To	Kristen Durocher	Page 1
CC		
Subject	Review of Sampling Procedures for Second and Third Rivers.

From	Ryan McCarthy and Donald Kretchmer
Date	March 26, 2013

Figure 1. Cross Section View of New Sampling Method.

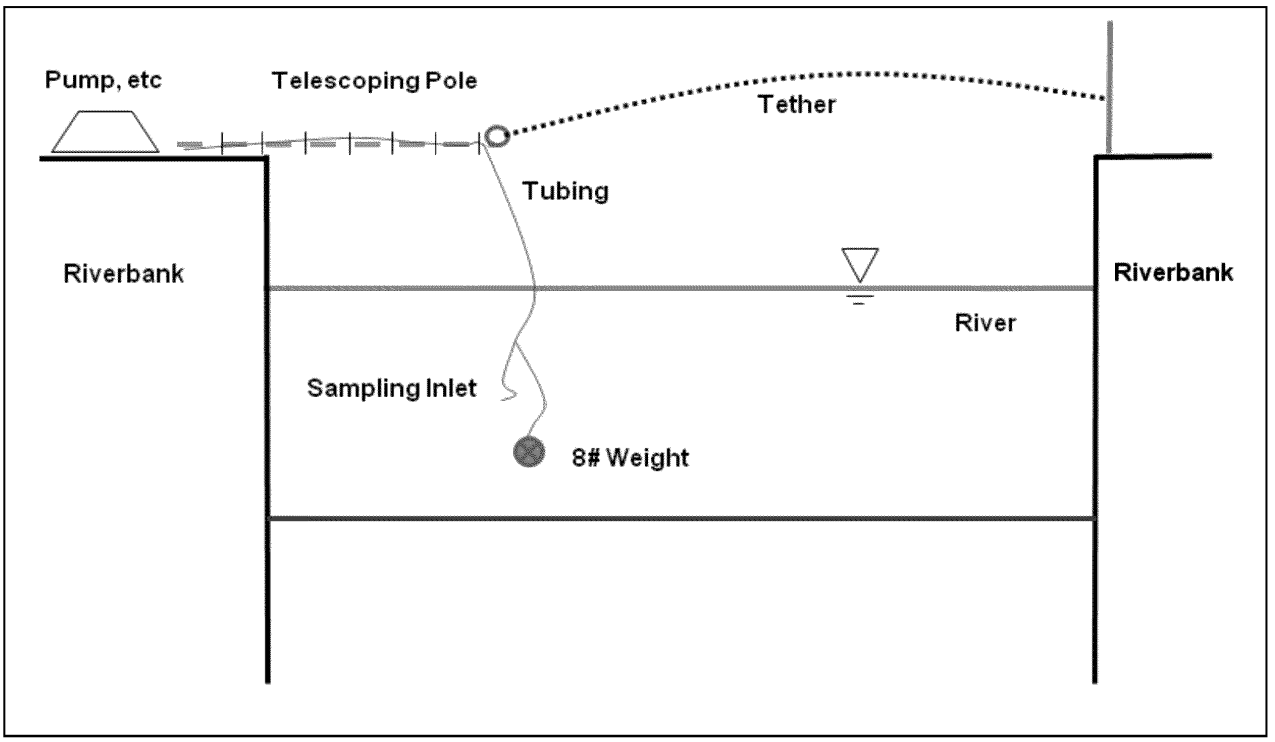
Therefore, an alternate approach for sampling the Second and Third Rivers is proposed. A telescoping 20' fiberglass pole will be employed to extend the tubing towards the center of the channel. While the 20' pole may not extend to the middle of the channel, the new sampling approach does allow a more safe and reasonable protocol to be employed and eliminates the need for field team members to enter the water. The pole will be deployed in a location where the main flow of the stream can be sampled and will not be deployed in backwater or eddy areas. A length of line will be attached to a fixed point (e.g., a tree, fence, etc) on the opposite bank in order to provide additional support against the flow for the sampling array.

The sampling tubing will be mounted with zip ties to the fiberglass pole. A decontaminated, 8 lb. plastic coated lead weight will be attached to the sampling tubing (via a suitable length of line and electrical tape or zip ties) approximately 1 foot below the sampling inlet in order to keep the tubing submerged and suspended at mid-depth in the water column. The approximate depth of the tributary will be determined and the length of the line holding the weight will be shorter than the presumed depth. All reasonable attempts will be made to avoid having the weight make contact with the river bed (and thereby potentially stirring up sediments).

Figure 2. Plan View of New Sampling Method.

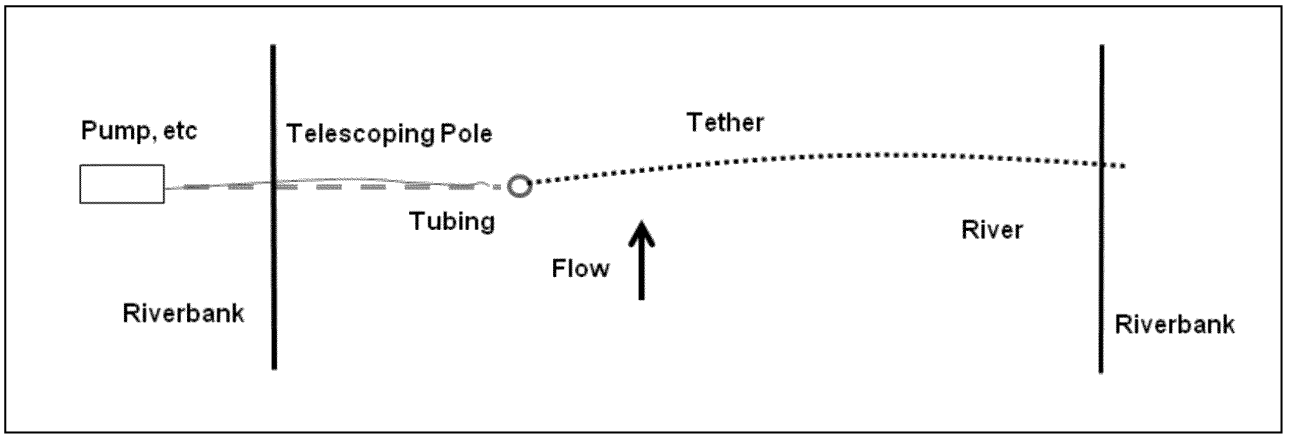
The pole will be anchored to the shoreline dependant on the conditions present at each sampling location. If there is a suitable fixed point for the pole to be attached to (e.g., a tree or fence), the pole will be tied off or lashed to the fixed point. If there is only flat

ground available, then using re-bar, tent stakes, or a large weight (e.g., cinder blocks) the pole will be fixed to the ground using the most prudent and effective method.
